SYDNEY OLYMPIC PARK

Finalisation Report

Review of Master Plan 2030 and *State Environmental Planning Policy (State Significant Precincts)*

November 2017

Central Precinct - Site 4B

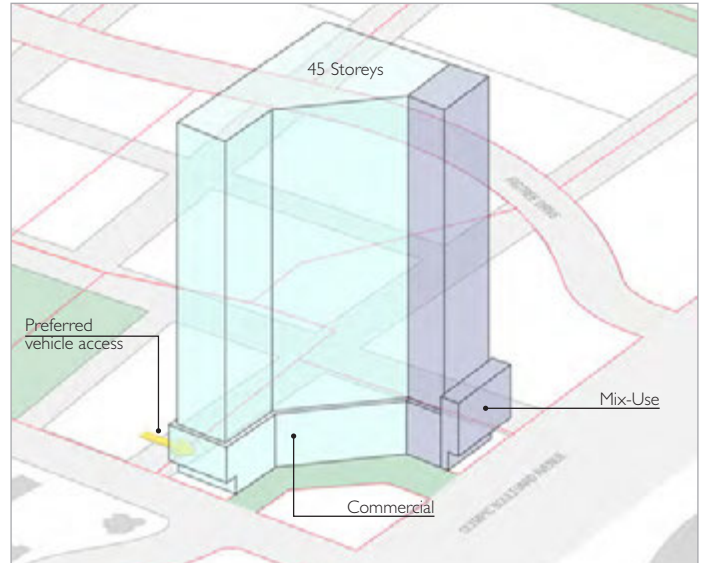
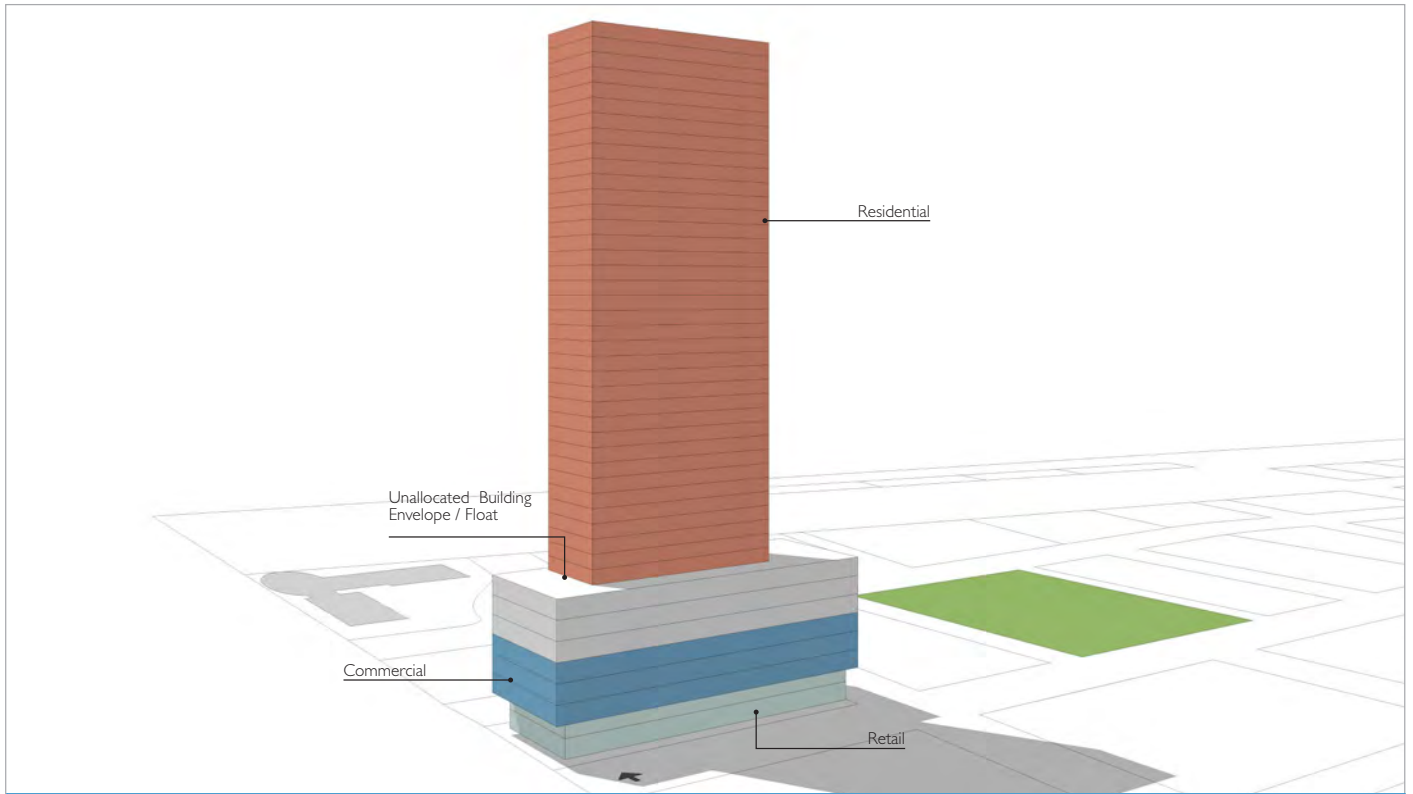
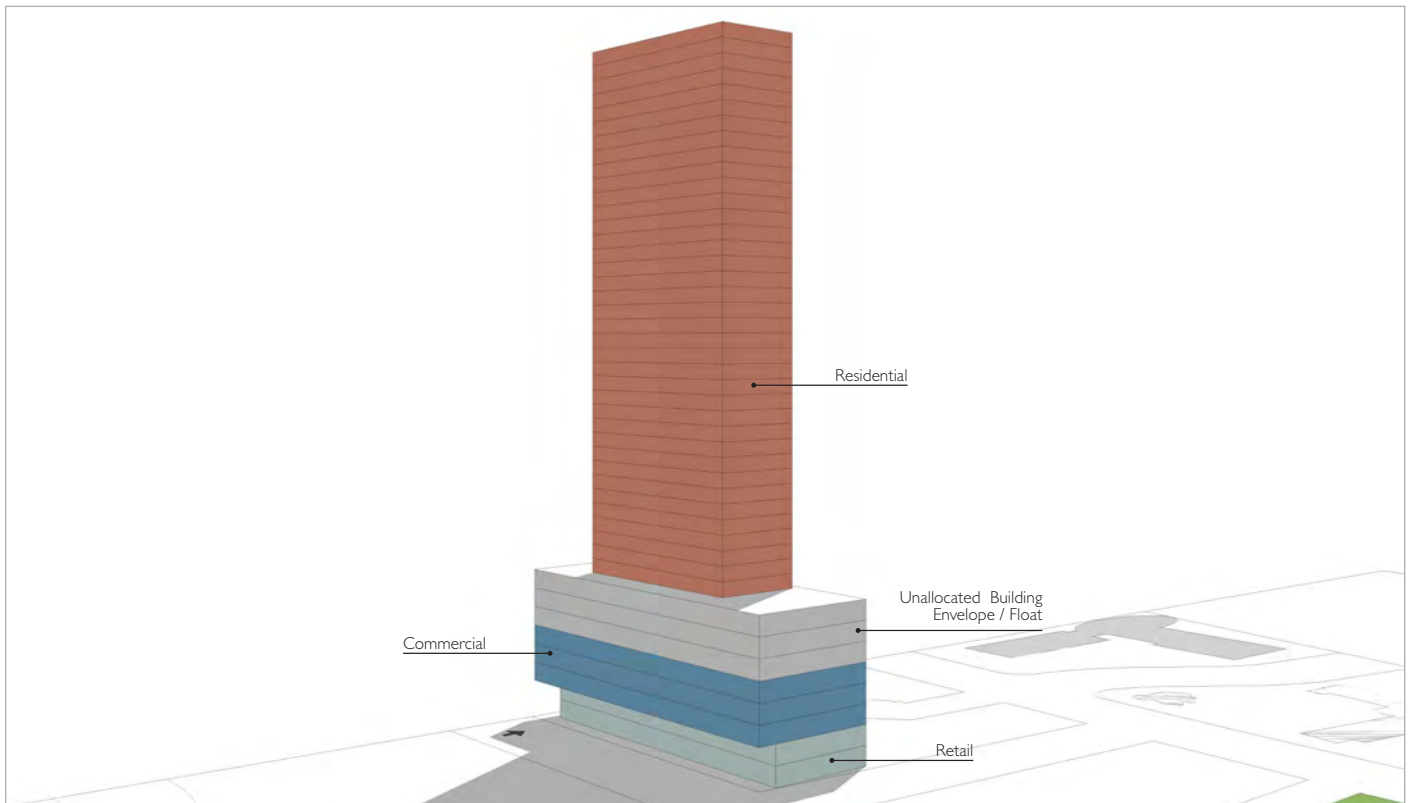
Request: Providing a site-specific exception to the 28m mandatory podium height along Olympic Boulevard to allow for transition north to south.

Response: The Draft considers sites in the context of the objective of delivering a resultant built form of the precinct is cohesive and coherent. The 28m podium height is a control for Site 4B is consistent with that objective.

- Consider widening the mixed commercial and residential land use zoning to reflect Figure 7 below
- Consider FSR up to 9:1*
- Consider providing a variation exception to the 28m mandatory podium height along Olympic Boulevard to allow for a transition from the Pullman Hotel to the north and the sites to the south of Site 4B.

- Amendment to Figure 5.6 – Central Precinct Site Floor Space Ratios Plan to allow a FSR of 9:1 on Site 4B.
- Amendment to Figure 5.7 – Central Precinct Land Uses Plan to allow Mixed Commercial and Residential on a wider portion of the site as shown in Figure 7 equating to dimensions approximately 50m (L) and 24m (W).
- Amendment to 4.6.8 Podium Design and Setbacks, providing a variation exception for Site 4B to the mandatory 28m podium height along Olympic Boulevard in order to achieve a podium transition from north to south along Olympic Boulevard.

Central Precinct - Site 43 & 44

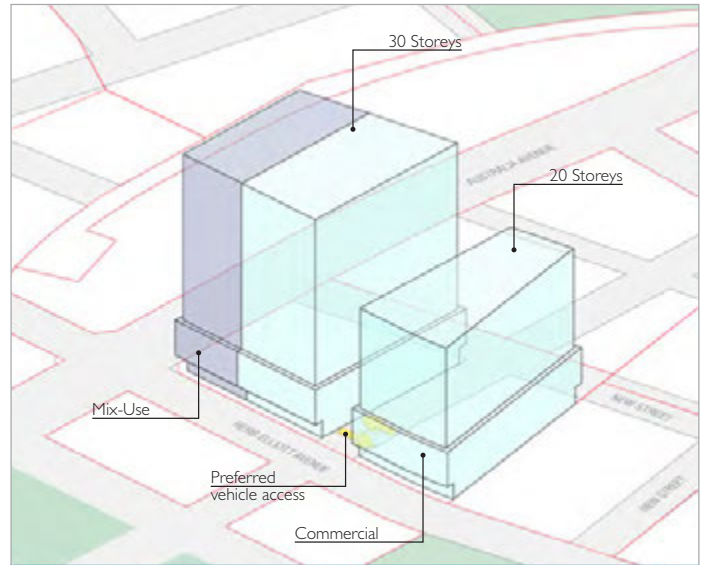
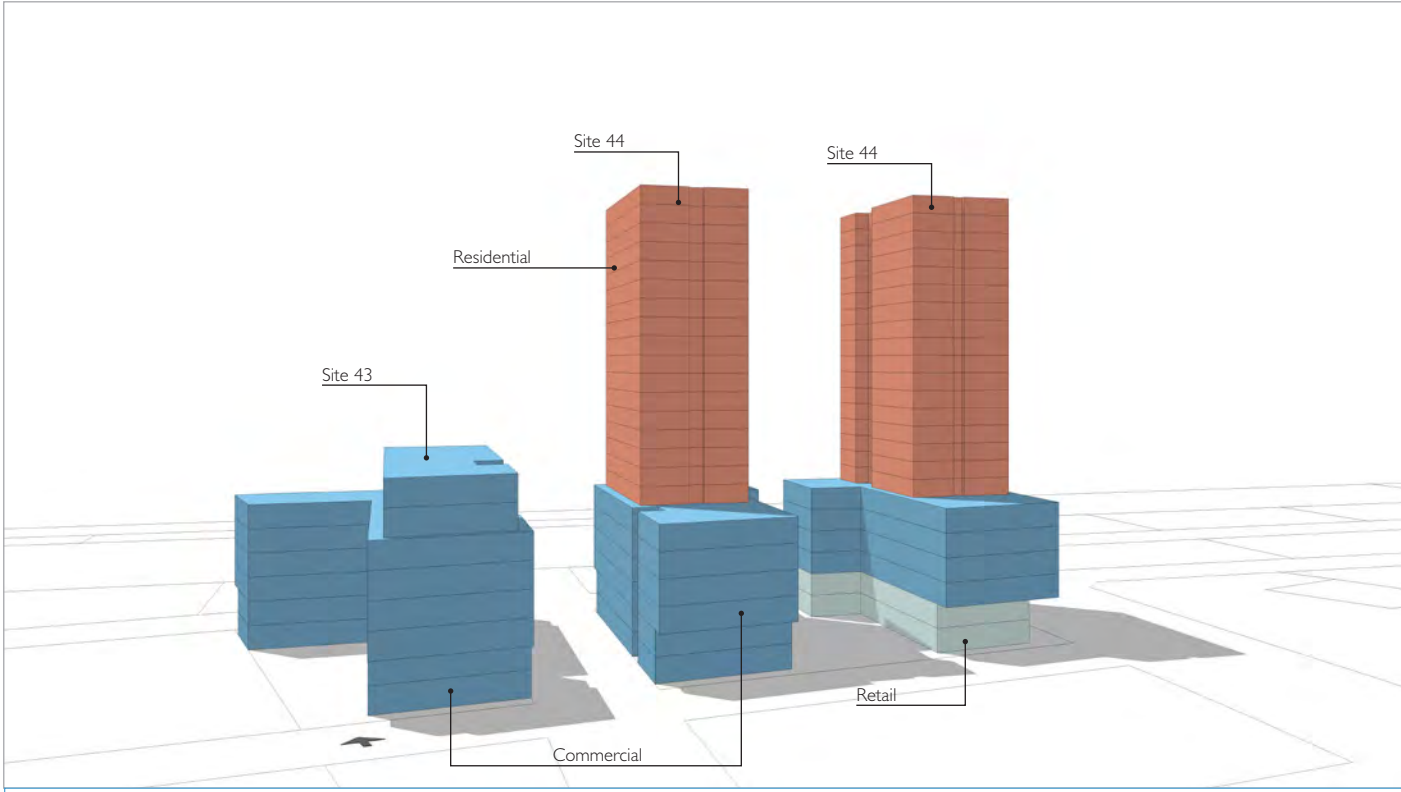
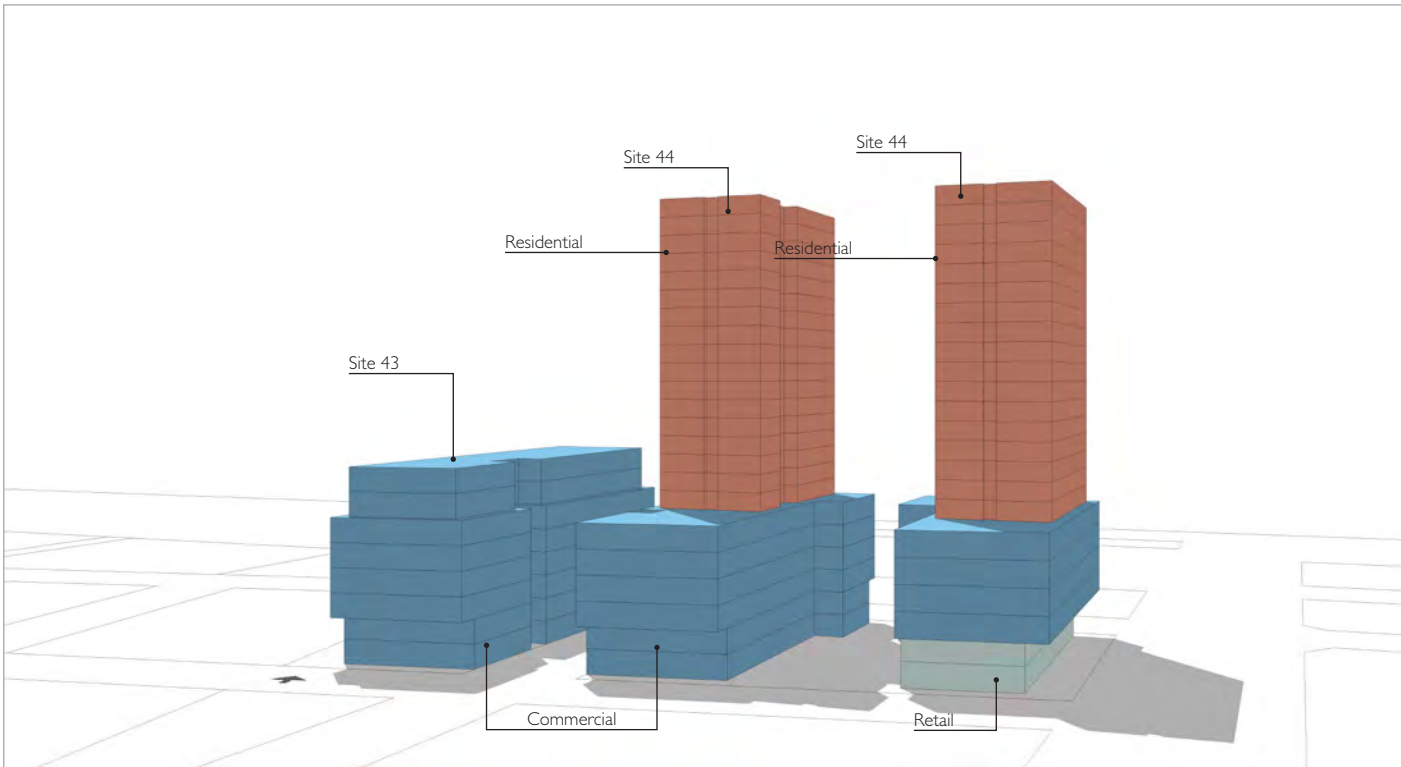
The detailed testing of the site has revealed that Site 43 and 44 achieves the total GFA, desired mix of uses and is in broad alignment with all built form controls as proposed within the Draft.

However, to deliver a better built form outcome we recommend amending Figure 5.7 so that "Mixed" uses applies to the full extent of site 44 which will enable a configuration of a 6-storey podium, achieving the 90% build to line and comprised of a mixture of commercial with two residential towers above.

Central Precinct - Site 45A

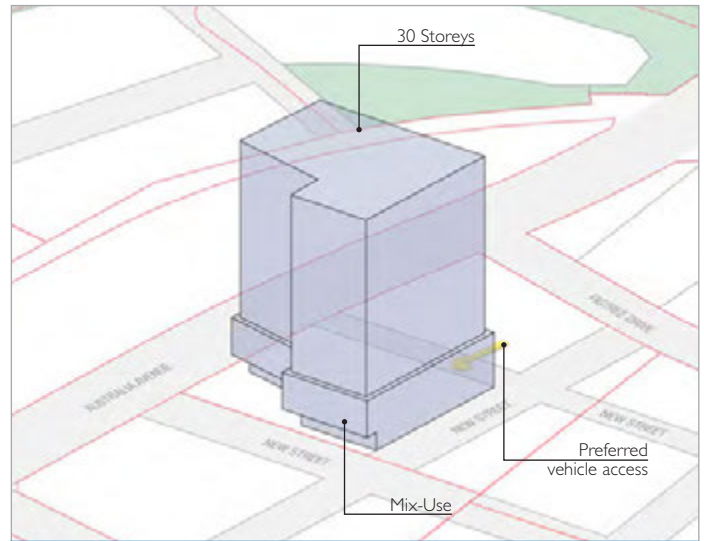
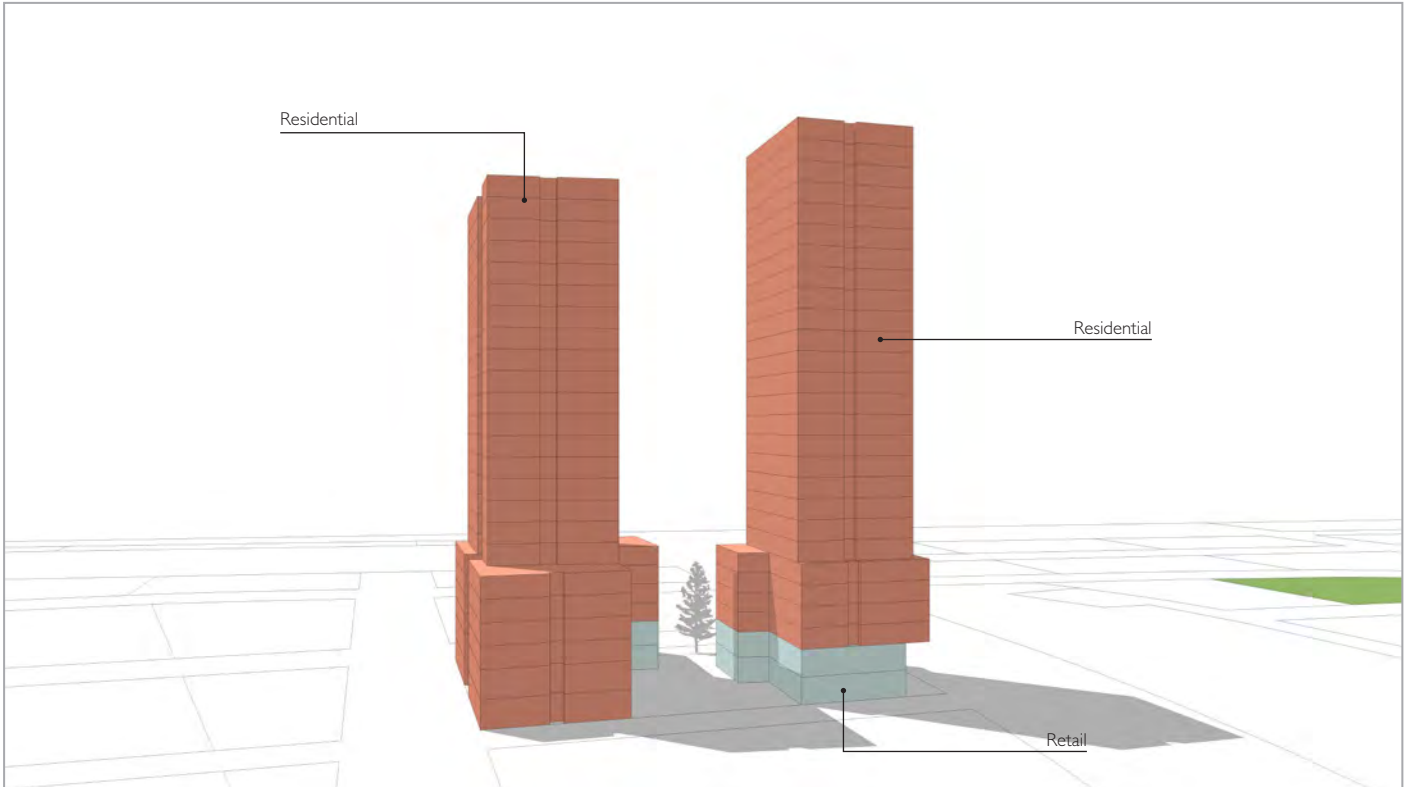
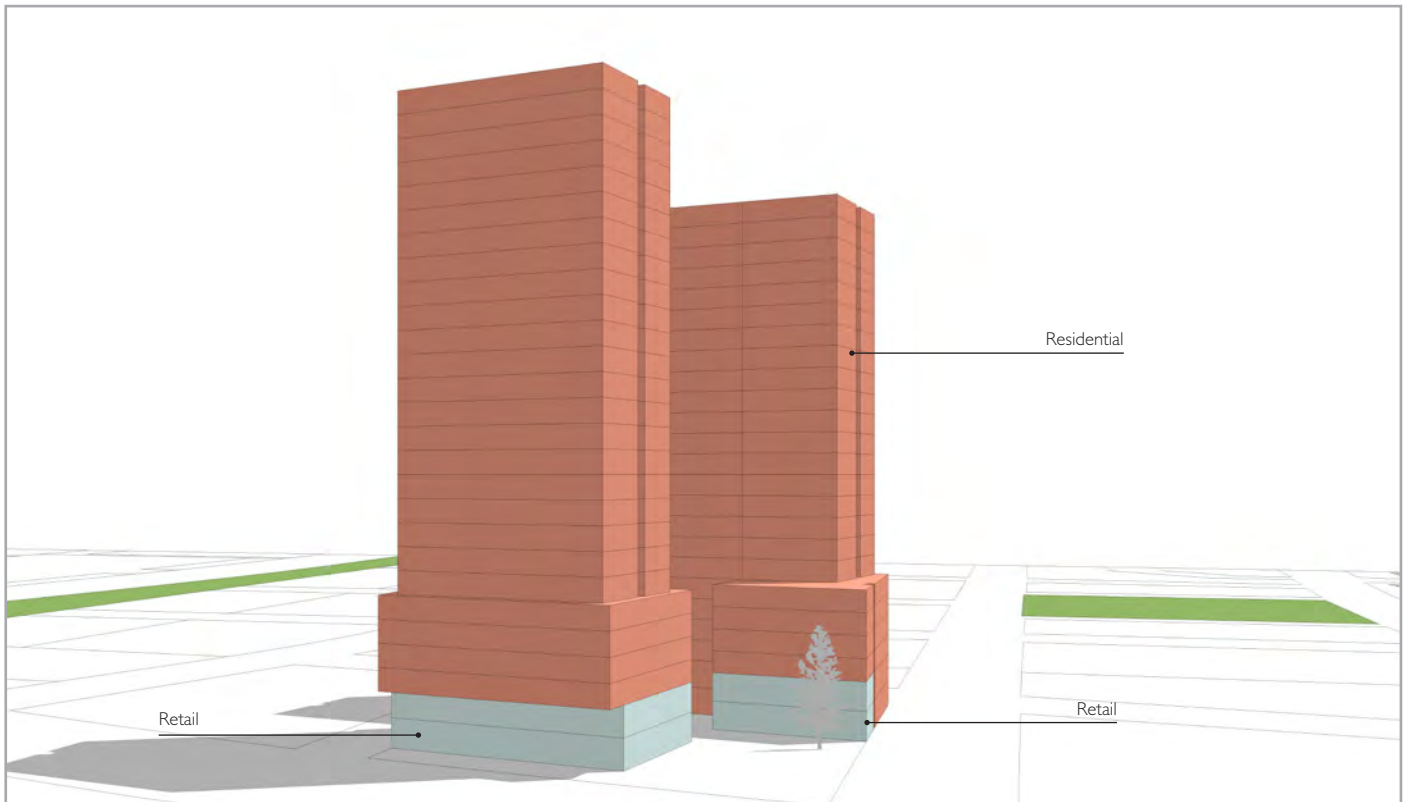
Site 45A has been deemed appropriate to deliver some of the job growth anticipated for the precinct due to their proximity to the station and interface with congruous uses. If the Draft is to achieve the job targets for the precinct, it is recommended that location and quantum of sites zoned for non-residential uses remain the same.

Central Precinct - Site 50

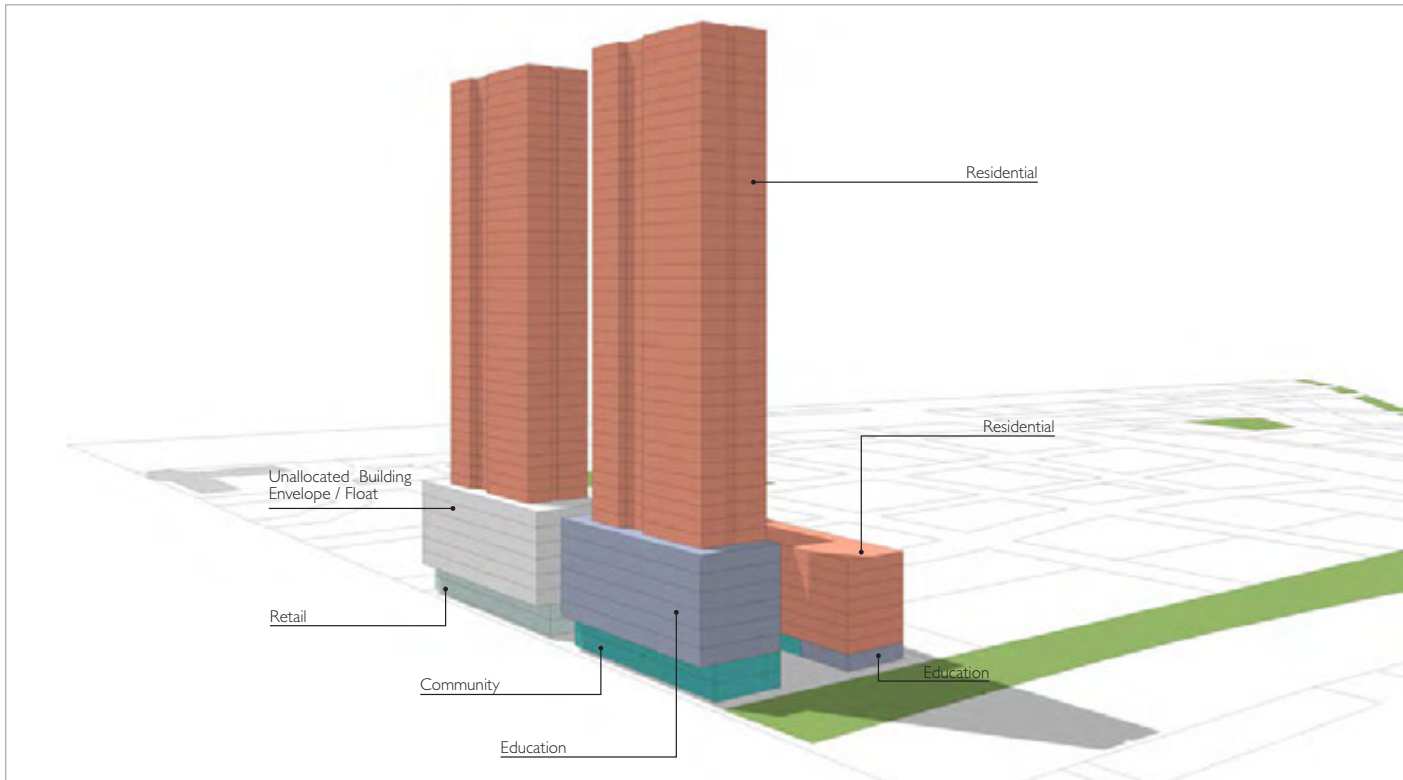
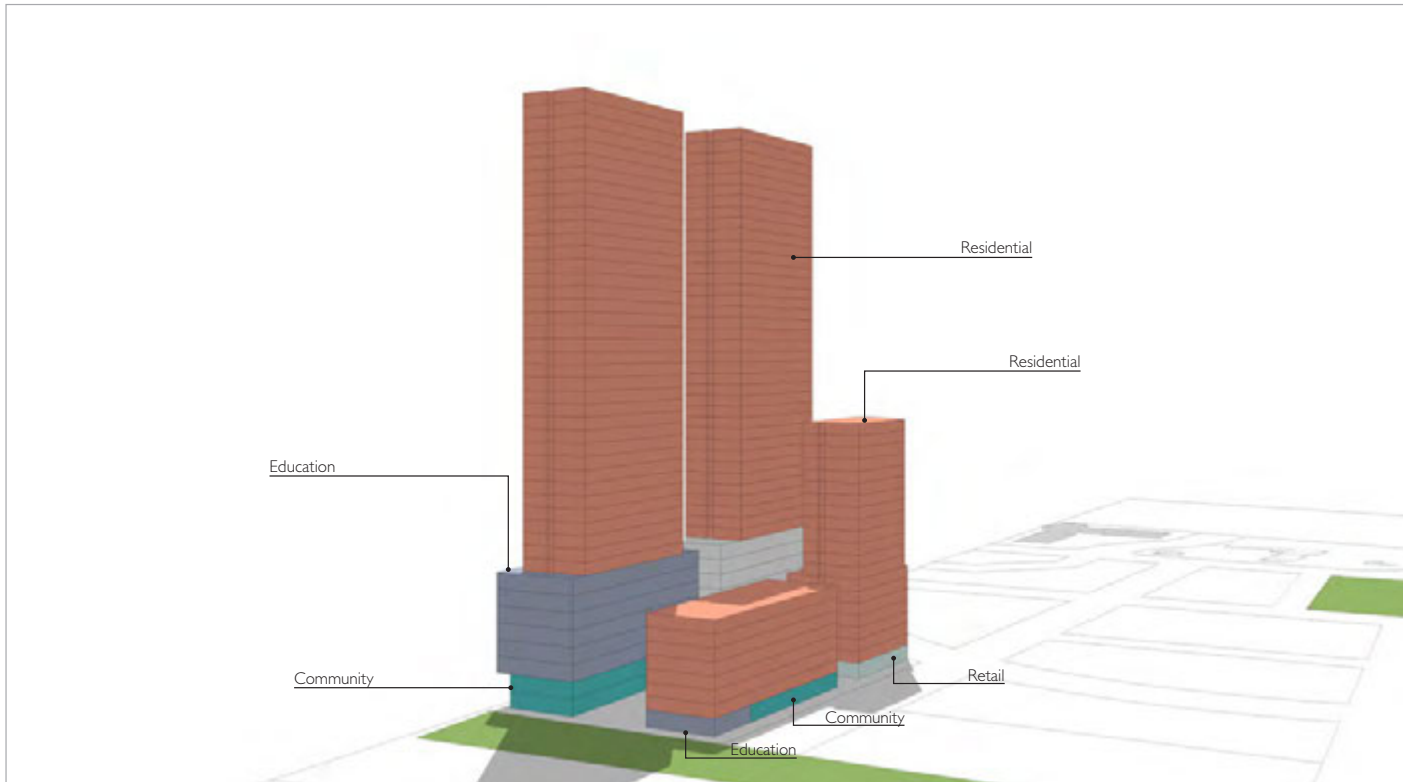
It is not clear if the current land use and area designations from the Contributions Plan are purely a guide or in effect form a quasi-land use control layer for the site read in conjunction with the SEPP. Either way, our client believe that the notation of mixed commercial, residential, hotels, serviced apartments use is appropriate as identified in Figure 5.7 of the draft Master Plan. For the reasons outlined earlier, the clients desire to maintain space for education purposes no longer exists and thus regardless of the quantum of non-residential floorspace, we request flexibility to plan for the most appropriate use mix and not have prescriptive controls.

Response: The current prescribed uses within the ICF can more than be accommodated within the built form controls for the Site. The result is that either residential is delivered within a podium, which will, as the leaseholder identifies, deliver a diminished level of amenity and quality of apartment within the podium.

The detailed testing of the site has revealed that Site 50 achieves the total GFA, desired mix of uses and is in alignment with all built form controls as proposed within the Draft.
